CELL 4 DESIGN

WHITE MESA PROJECT  
BLANDING, UTAH

Re: Cell 4 Design  
White Mesa Project  
Docket No. 40-8681 04008681210R

Please find enclosed three (3) copies of the response to the questions and concerns that you addressed in your March 15, 1989, letter to Mr. D. K. Sparling concerning the Cell 4 design for the White Mesa Project.

FIGURE 2.6-9

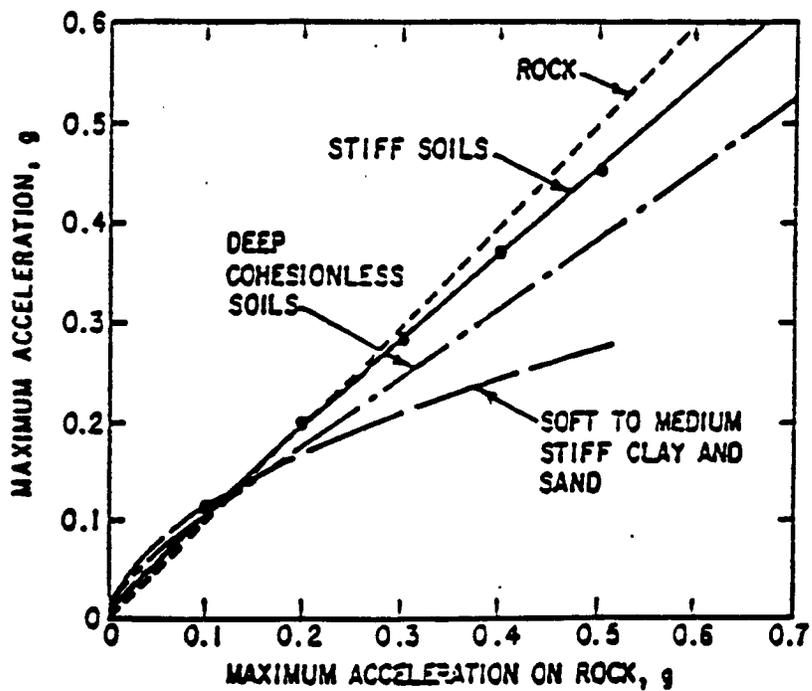
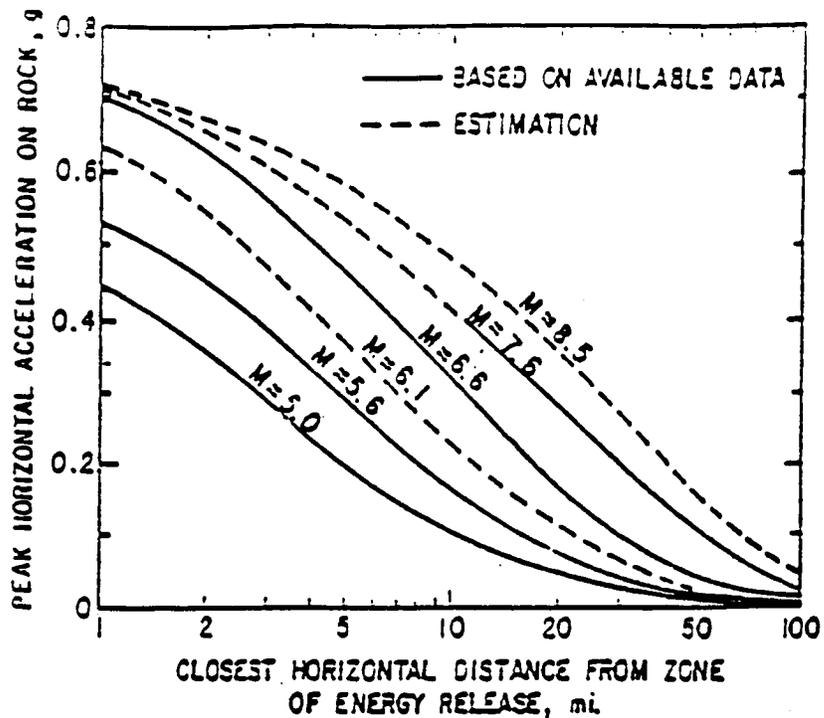
3. The liquefaction analysis that determined the potential for liquefaction was "nil" - must be included in the Plan.

Ground motions at the White Mesa project site resulting from an maximum credible earthquake (MCE) on the fault discussed can be estimated from attenuation curves established by Seed and Idriss (1982). The graph in Figure 2.6-9 indicates an estimated peak horizontal acceleration at a distance of 57 km from the epicenter would be 0.07g.

UMETCO MINERALS CORPORATION  
 WHITE MESA PROJECT  
 STABILITY ANALYSIS  
 - CELL 4 -  
 MAXIMUM HEIGHT SECTION  
 JUNE, 1988  
 FIGURE 3.4-1

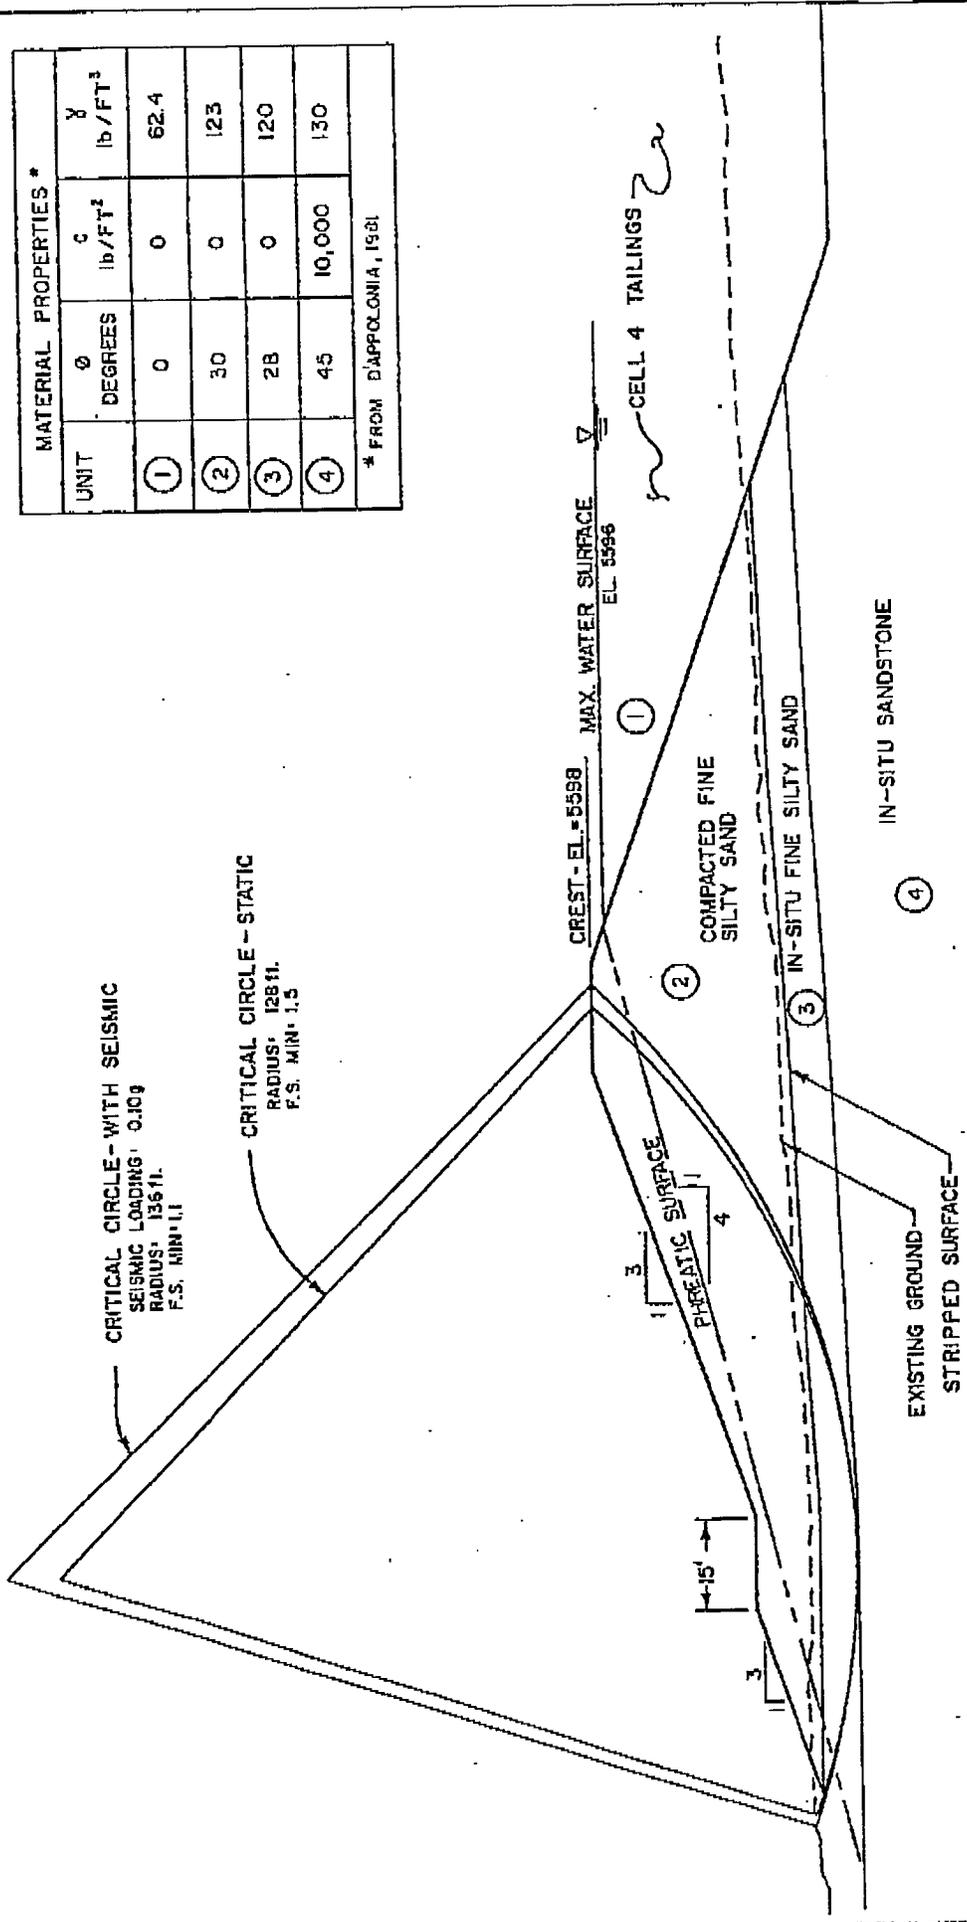
Response:

Please also note Figure 3.4-1 of the Cell 4 design package. The stability analysis assumes that the synthetic liner has completely failed and that a phreatic surface (steady state seepage conditions) has developed within the embankment, adding to the conservatism of the analysis.

**'CROSS SECTIONS**

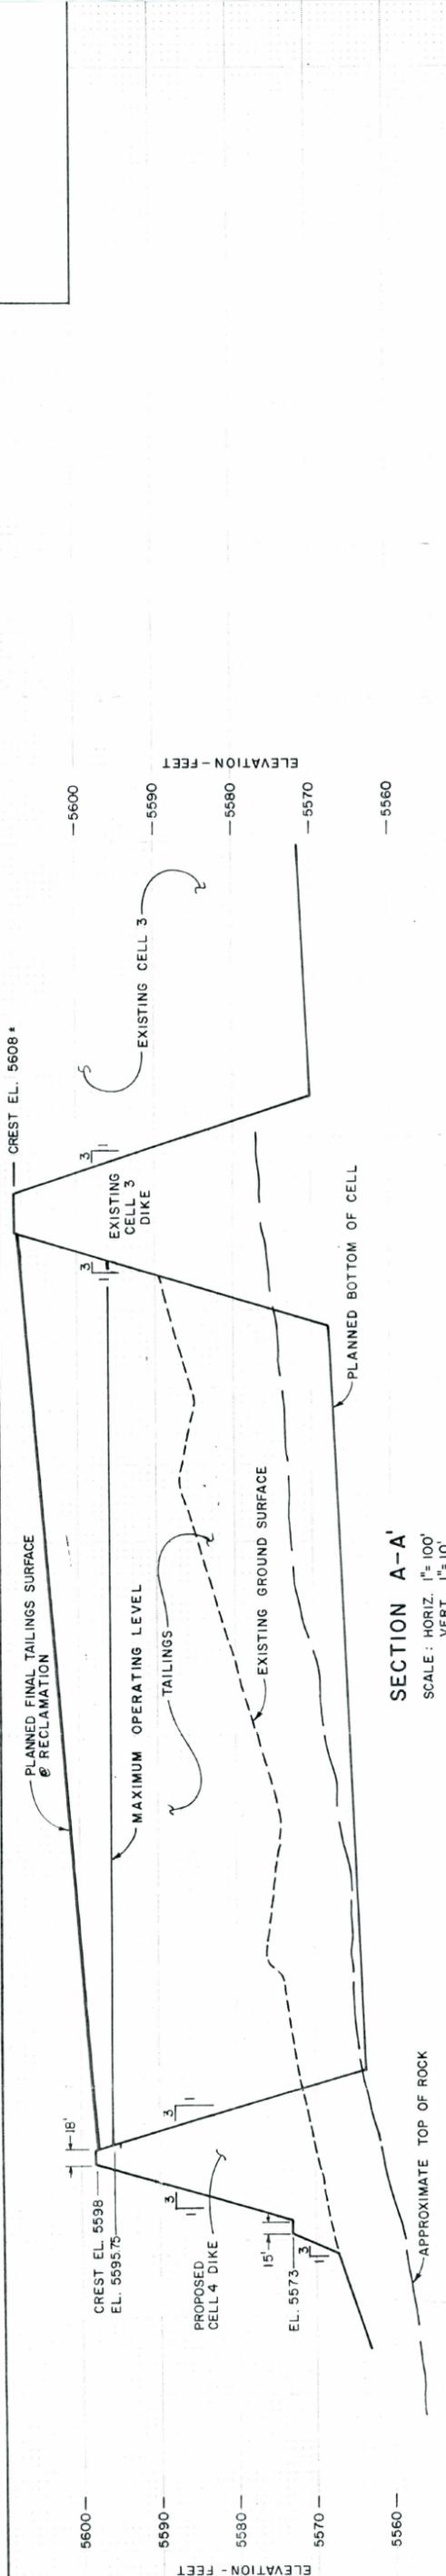
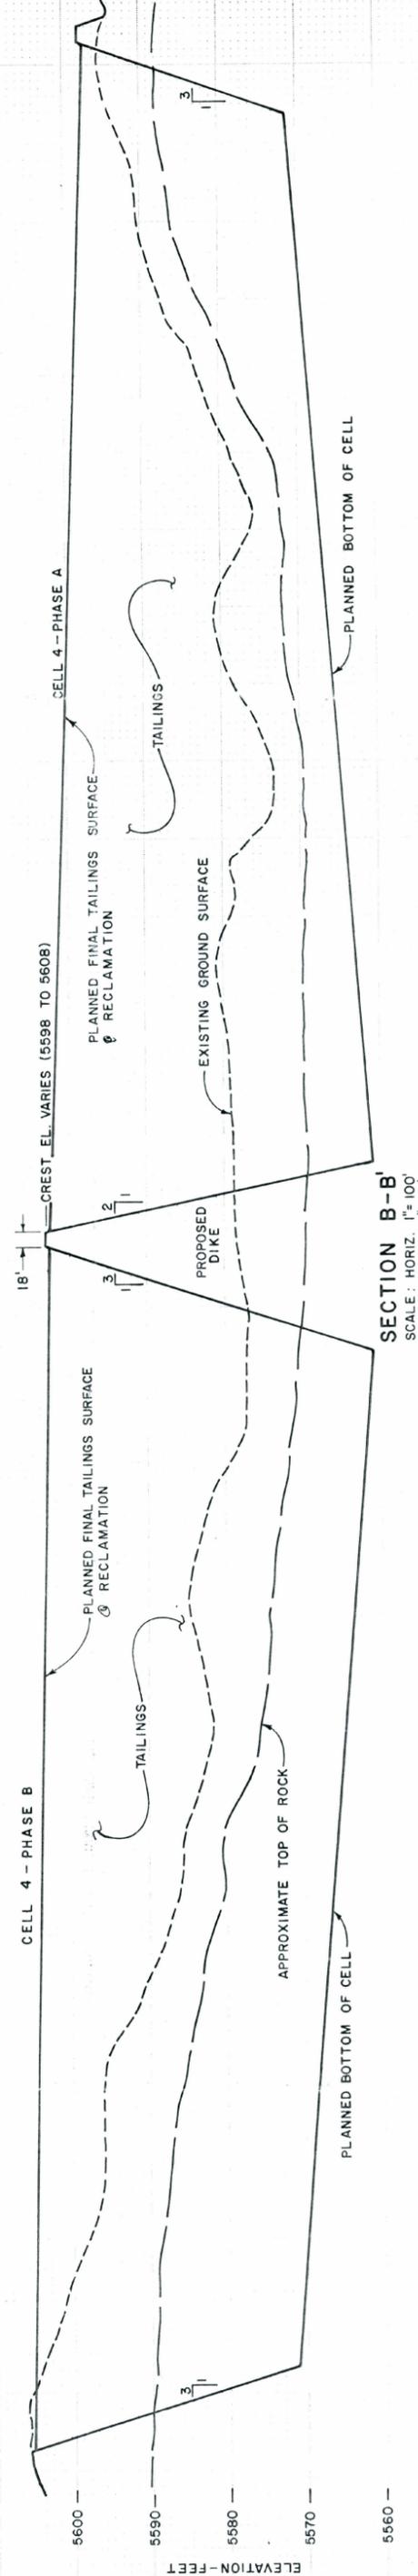
1. The surface water design must be included in the design package. The design must establish sufficient freeboard in the cells to allow for settlement and wind wave runup, along with providing available storage capacity to store the entire inflow from a 6-hour Probable Maximum Precipitation (PMP) event. For design purposes, you should assume that the reservoir level at the beginning of the PMP event is at the maximum level expected during the design life of the cells. The diversion ditch design must also be included in the design package.

Umetco will operate the cell to contain the PMP event of 10 inches with an additional 1.5 feet of freeboard to provide for wave runup due to wind. (See attached Drawing C4-2.)
